NOTICE TO ALL FIRMS

Re: Addendum Number 2
IFB # C1595 – Alumni Hall Reroof

2 REVISED PERIMETER
A.801.02 SCALE: 3" = 1'-0"

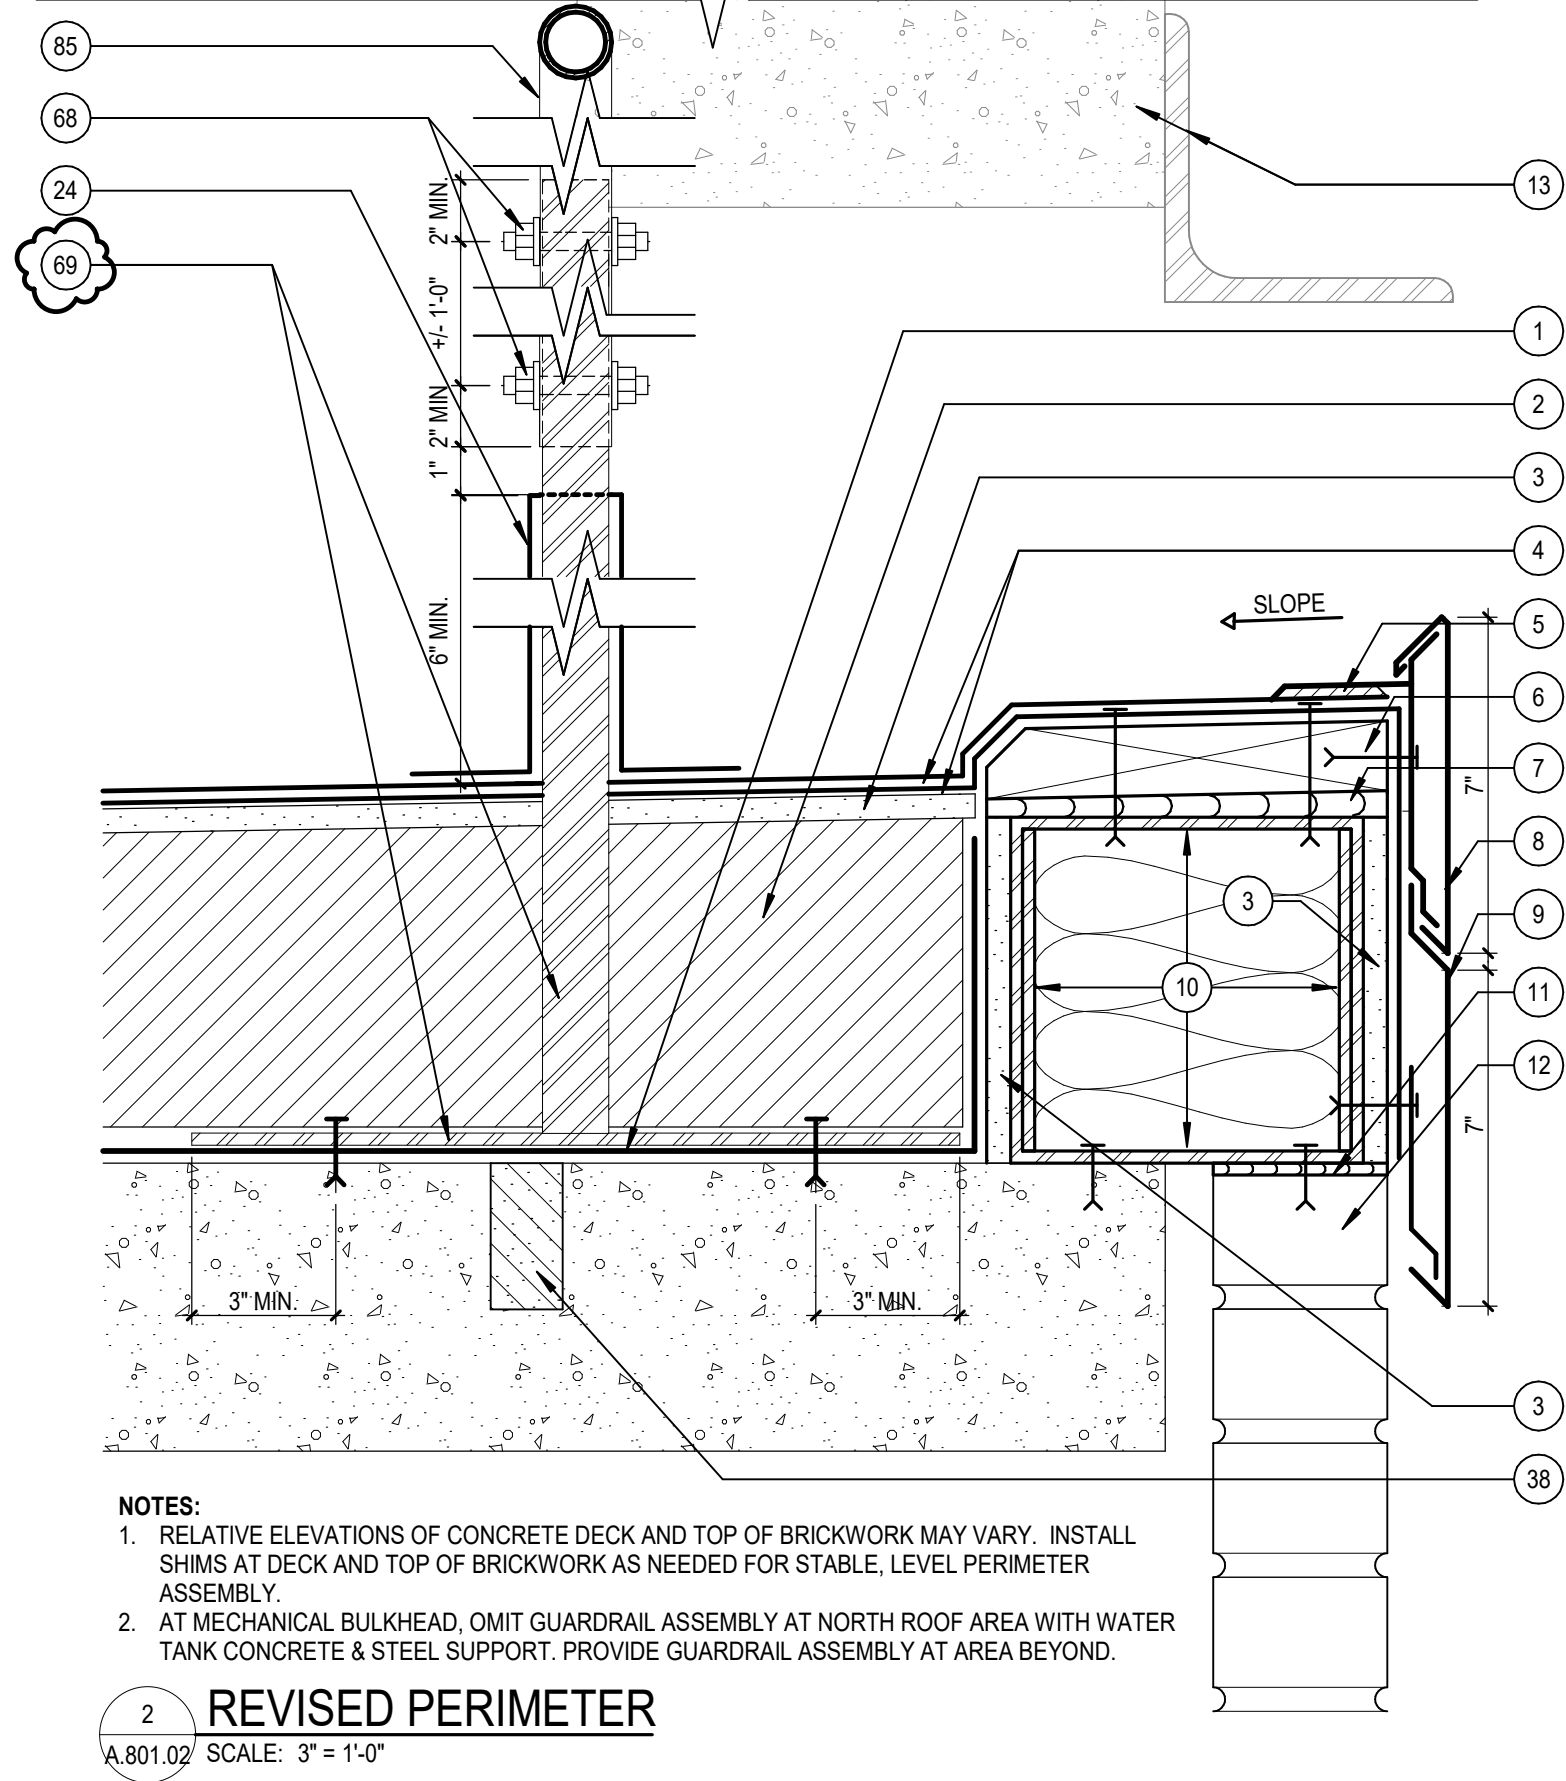
- 1) *Addendum #1 includes revised drawings, a revised Summary Specification 011000, and an appendix of supplemental existing condition information for reference. All revisions to the drawings have the suffix ".01". The revised scope includes the additional work for the 18th floor covered northwest and northeast terraces on A.100.01 & A.803.01. Additionally, delegated design was clarified on A.801.01 for the connection of the guardrail. The revised Summary Specification, 011000, includes clarifications on work procedures and interior protection for the work on the 17th and 18th floor. Lastly, the supplemental existing conditions reference is the document of the existing plans and photographs that was shared during the walkthrough of the spaces not visited. Please follow up with any questions to FIT purchasing for any clarifications.*
